**SECTION 00 90 04
BIDDING AND CONTRACT REQUIREMENTS
ADDENDUM NUMBER 4**

Issued: October 12, 2023

Re: ADDENDUM NUMBER (4) TO THE BIDDING DOCUMENTS FOR

**McHenry County College
University Center at MCC**
Architect's Project Number: 22-050

SHEET NUMBER:
AD1.10

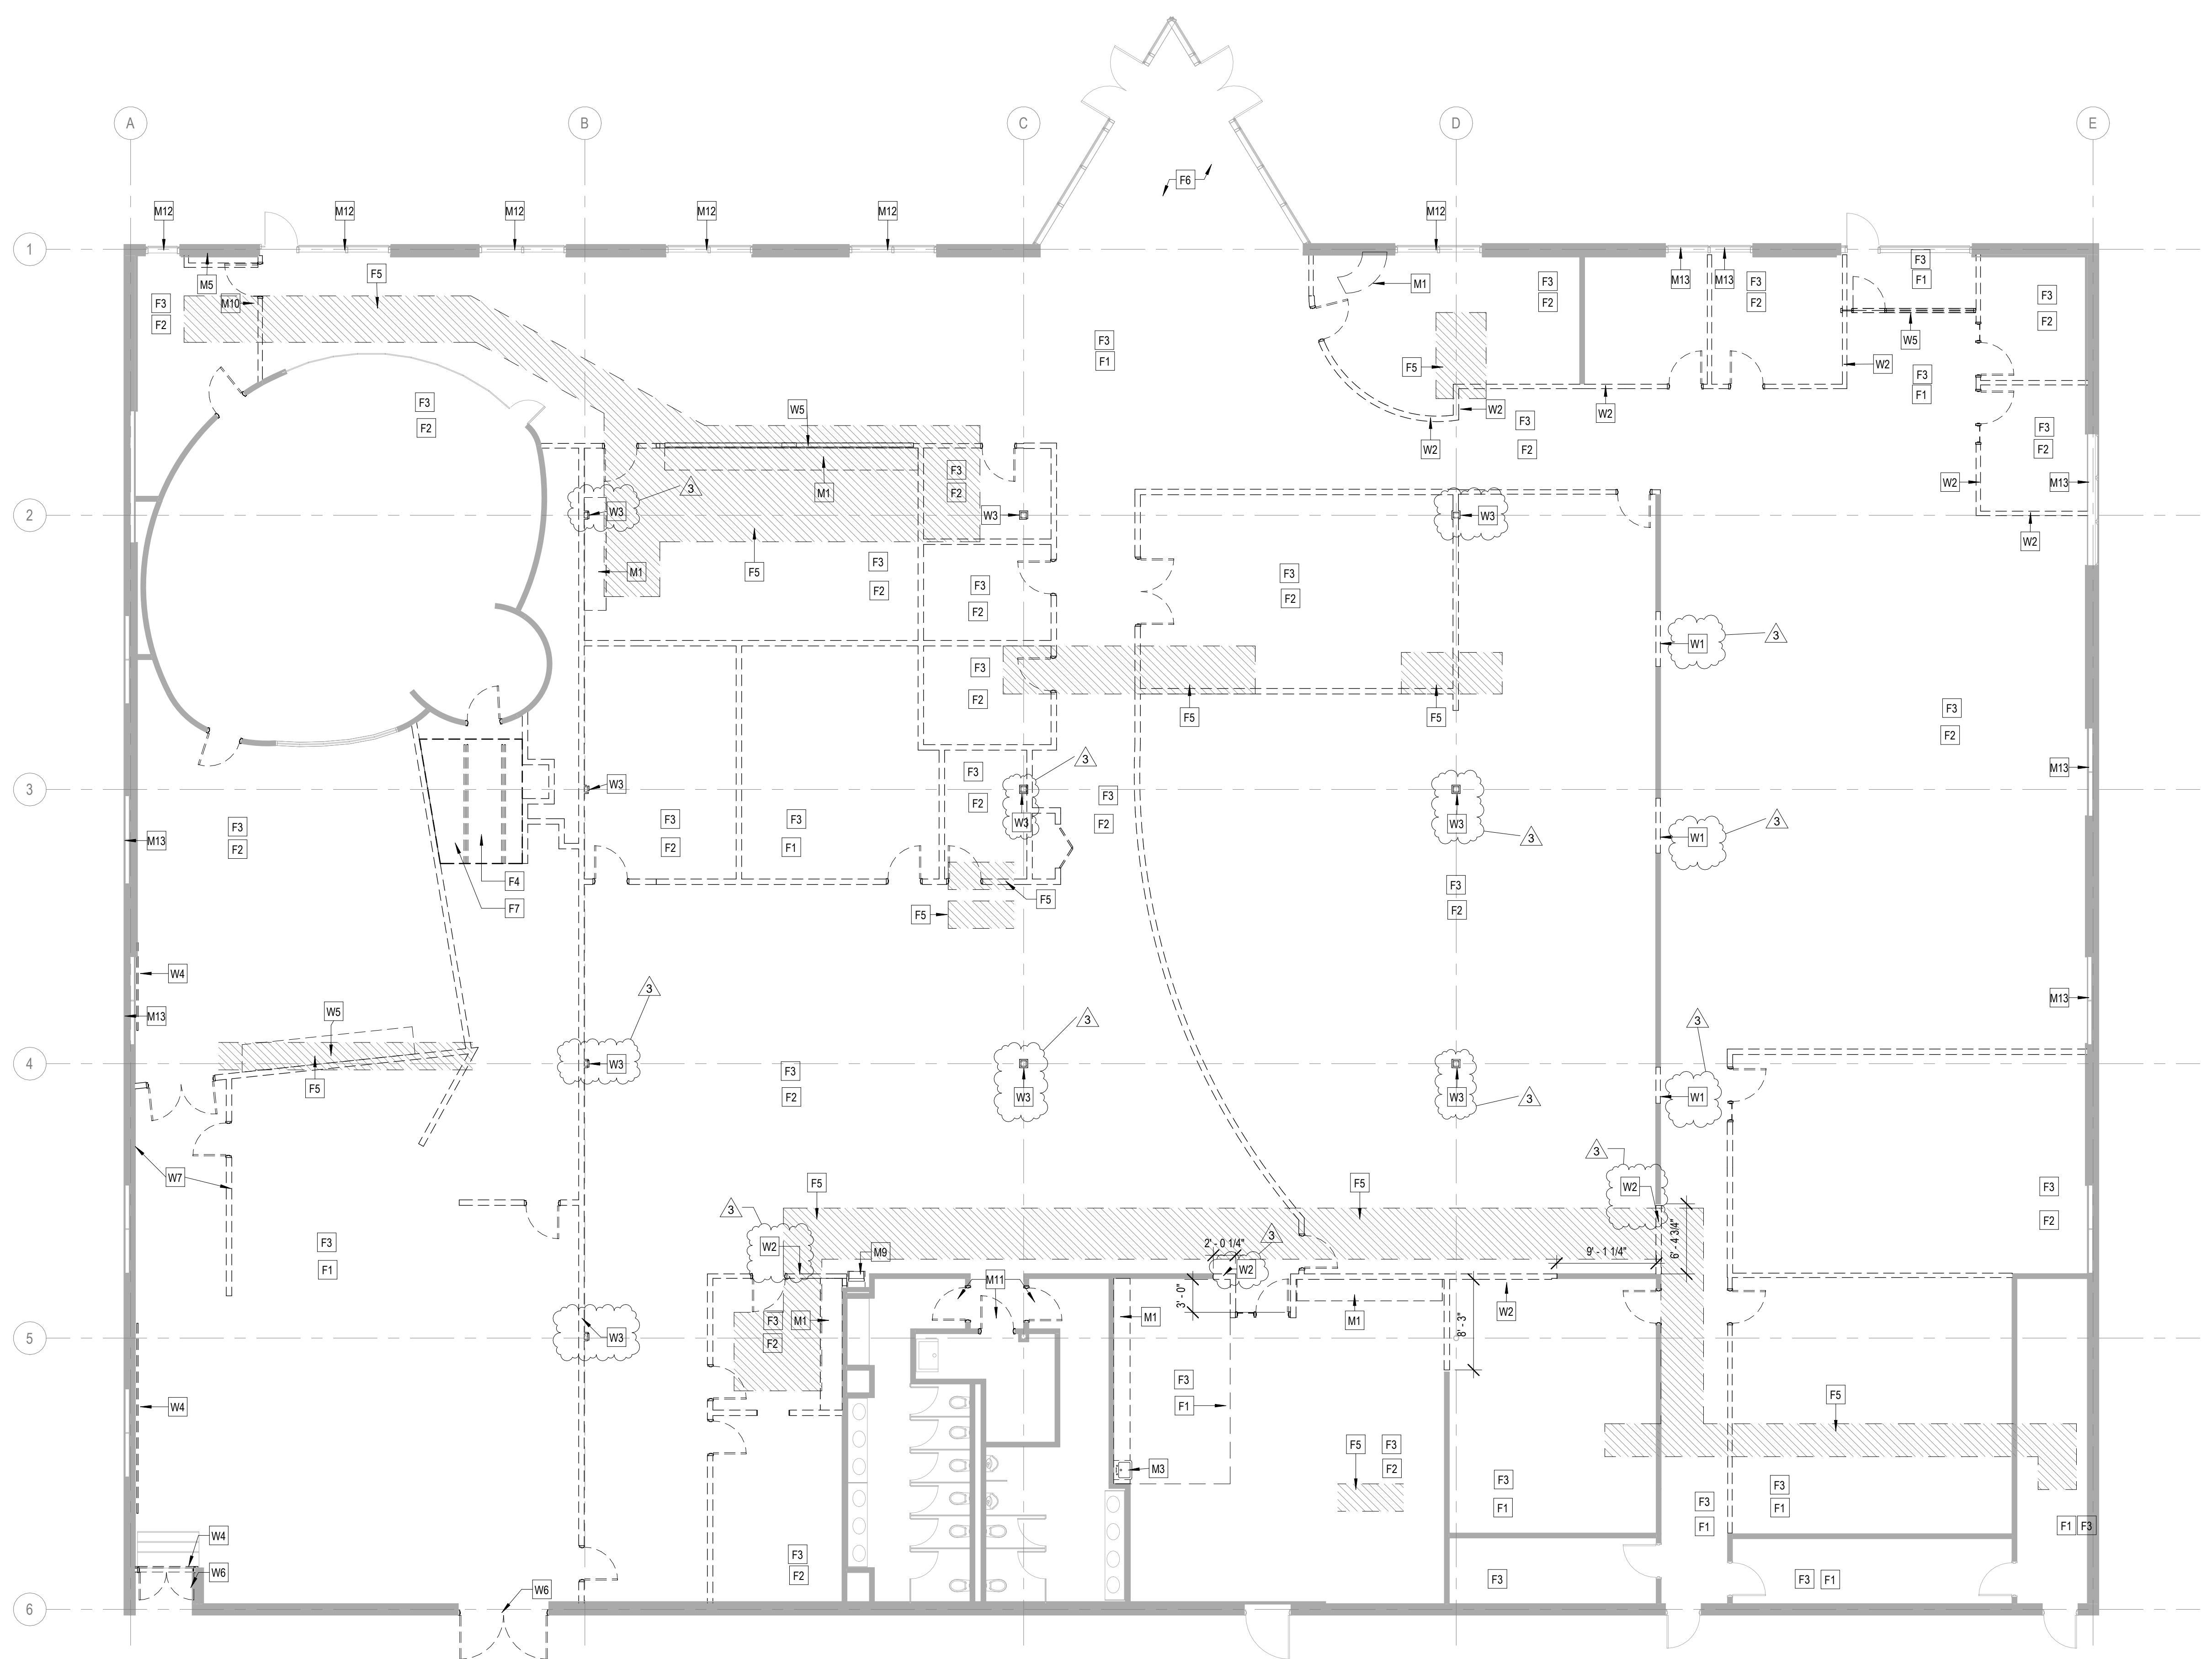
1. AD1.10
 - A. **REVISE** note W3 as indicated.
 - B. **REVISE** notes W1A, W1B, W1, W2, W3 as indicated on the drawings.
2. A1.11
 - A. **ADD** keynotes 13 and 14. Refer to plan for added locations.

SHEET NUMBER:
A2.11

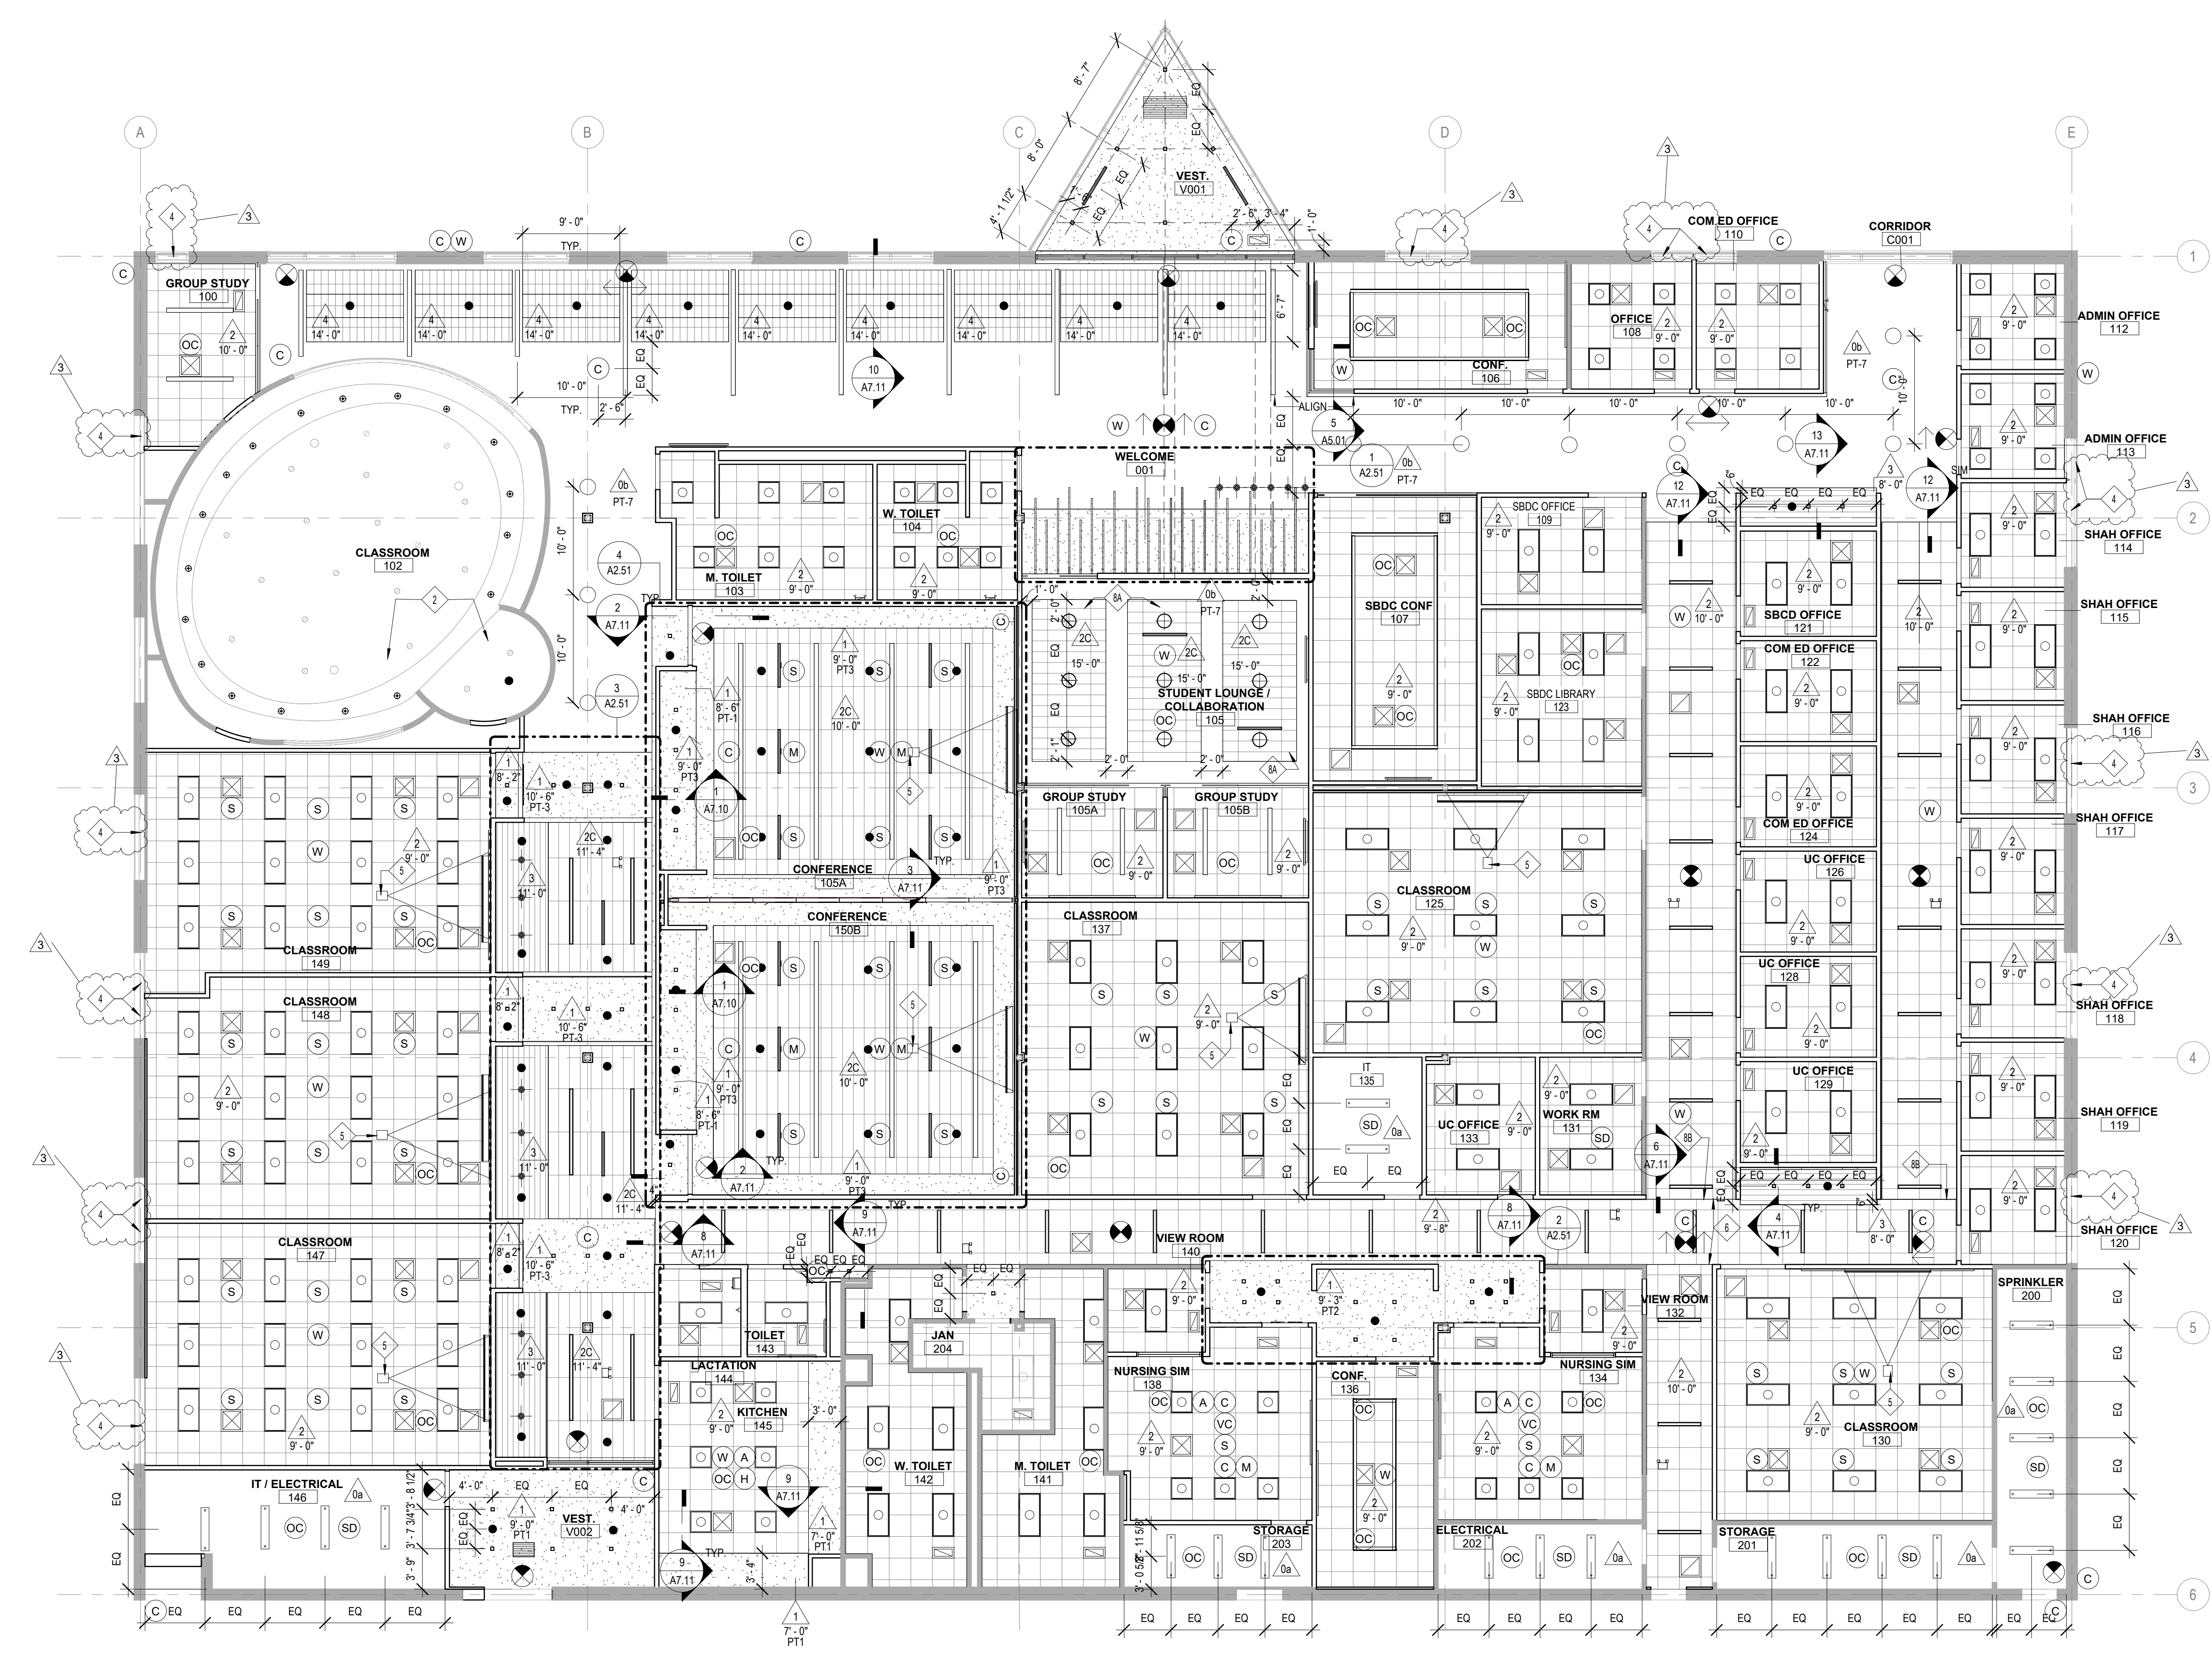
3. A2.11
 - A. **REVISE / ADD** locations of new work note 4 to clarify locations of new roller shades at existing windows.
 - B. **ADD** ceiling type 5. Refer to plan for added location.
